METROPOLITAN GOVERNMENT OF NASHVILLE AND DAVIDSON COUNTY

STAFF RECOMMENDATION 1504 Sweetbriar Avenue August 21, 2013

Application: New construction-addition
District: Belmont-Hillsboro Neighborhood Conservation Zoning Overlay
Council District: 18
Map and Parcel Number: 11704003200
Applicant: Kim Sabatini, Owner
Project Lead: Sean Alexander, sean.alexander@nashville.gov

Example of appropriate enclosure

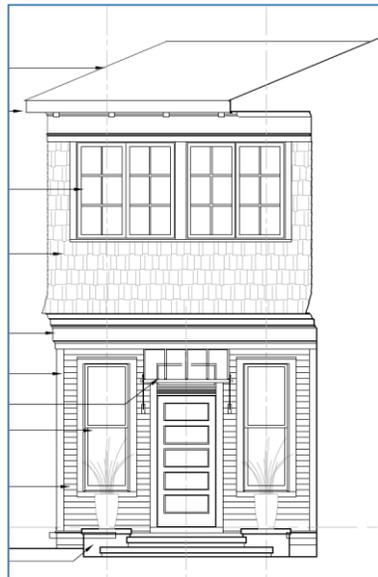
The design guidelines allow for an enclosure “if the addition is constructed in such a way that the original form and openings on the porch remain visible and undisturbed.” The Commission has consistently interpreted this to mean that an enclosure primarily of clear glass windows and/or doors with minimal framing that retains original columniation may be appropriate. Low bulkheads or knee-walls have been also been approved. Substantial enclosures with clapboard or bricked-in walls, however, have not been approved.

Staff finds that the proposed enclosure of the porte cochere would disrupt the form and appearance of the structure in a significant and negative way, and that doing so would not meet guideline II.B.2.c.

Additionally, the enclosure of an historically significant open space with solid and opaque materials would not meet guideline II.B.1.d and II.B.1.g. An enclosure primarily of glass with minimal framing elements as necessary, retaining the original columniation and the open nature of the space, would meet these guidelines.

Staff has had discussions with the applicant about what type of enclosure would meet the design guidelines. One option would be a sunroom that retained the majority of the existing openings with the existing columniation, with the enclosure materials being primarily glass with minimal framing.

1 PROPOSED FRONT ELEVATION

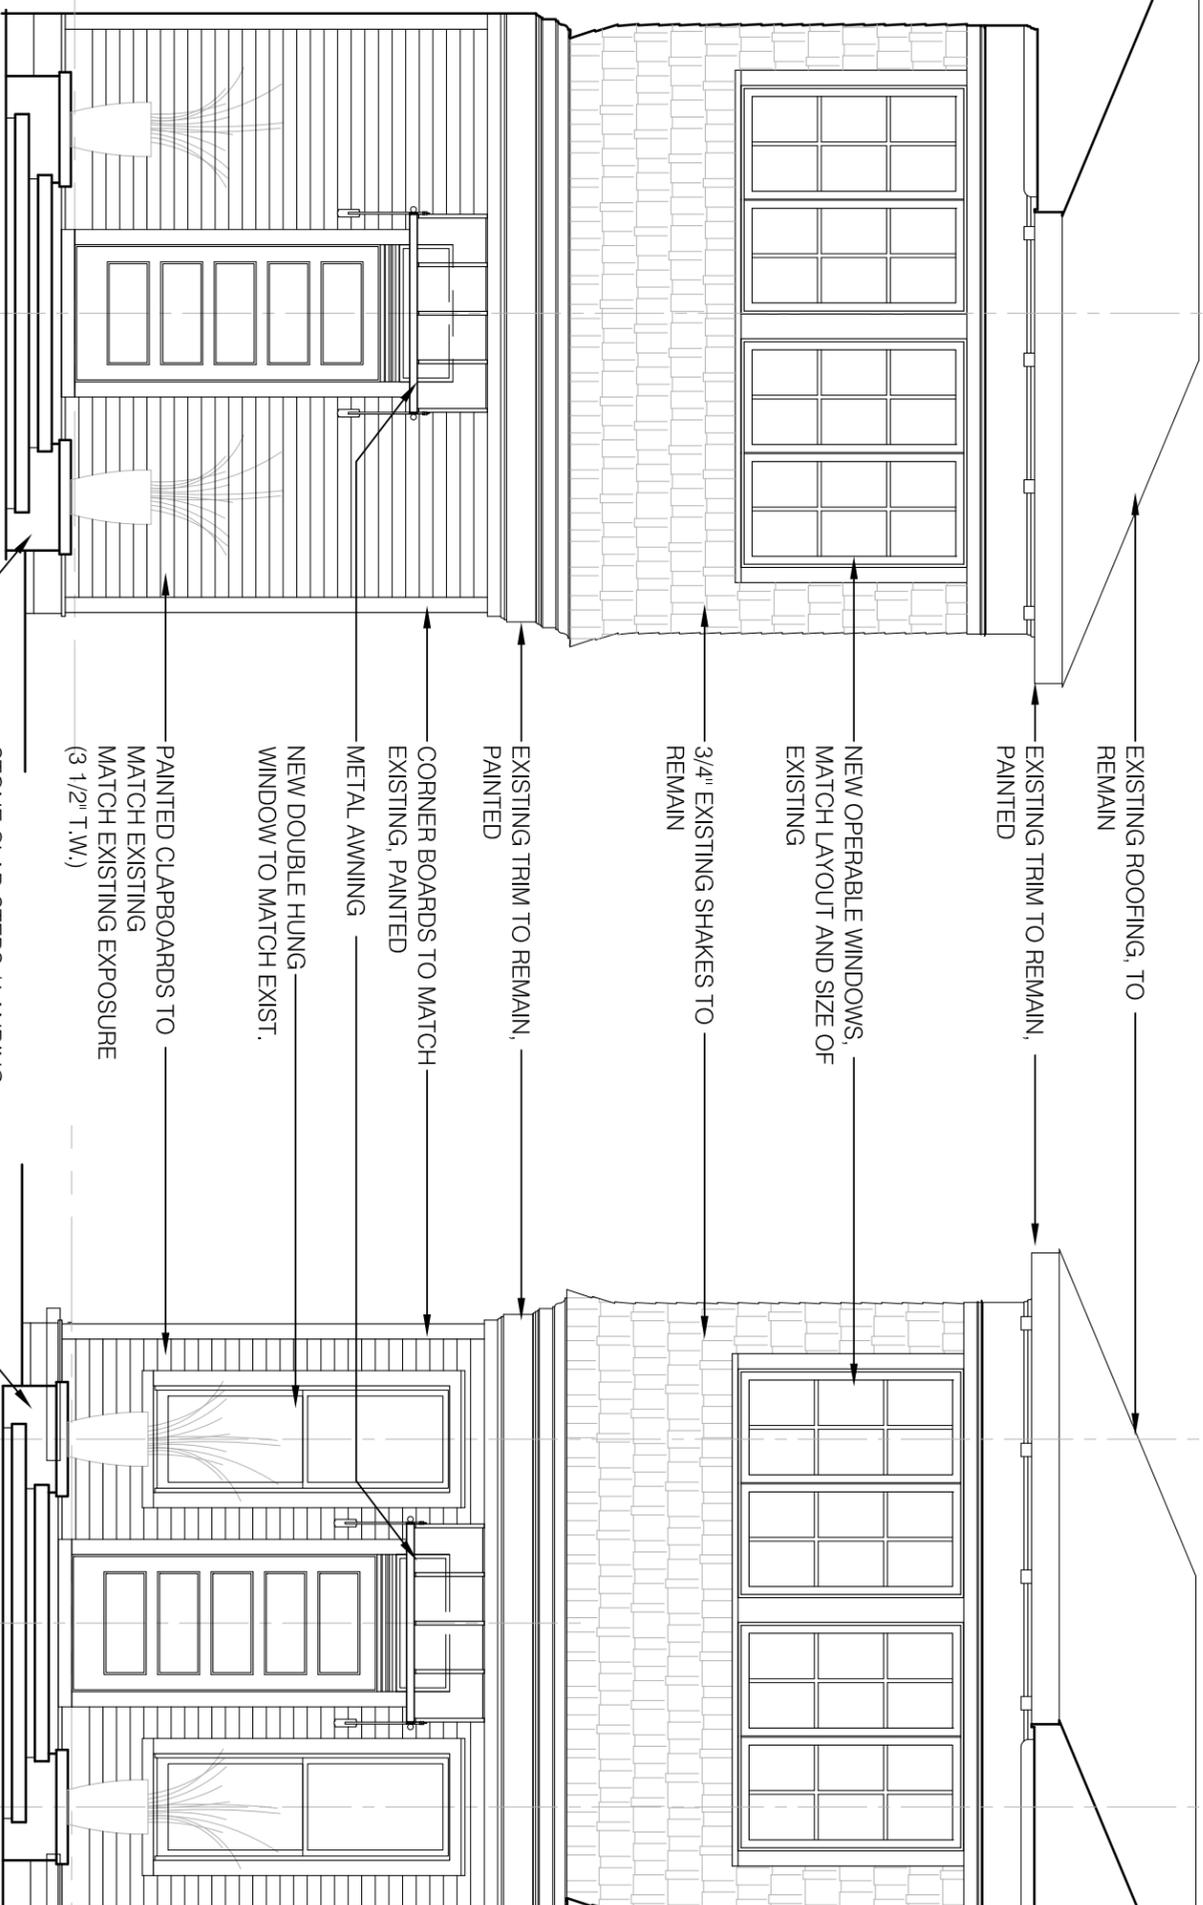
The applicant is proposing to enclose the existing porte cochere with frame walls with siding, cornerboards, and windows to match the existing structure. The front elevation will have a pair of double hung windows with a panel door in the center. The side elevation will have a single fixed window with a Victorian diamond-pane ornamental sash. The columns will be removed.

Of the existing openings, approximately one hundred, ten square feet (110 sq. ft.) in area on each elevation, the frame walls and solid door will leave less than twenty percent

(20%) of the front and less than ten percent (10%) of the side openings remaining, albeit as windows. The rear elevation will also have less than twenty-percent (20%) of the existing area remaining open.

Staff recommends disapproval of the application, finding it does not meet the Design Guidelines for the Belmont-Hillsboro Neighborhood Conservation Zoning Overlay. Because of the significant alterations required for the proposed design to meet the design guidelines, approval with conditions is not recommended.
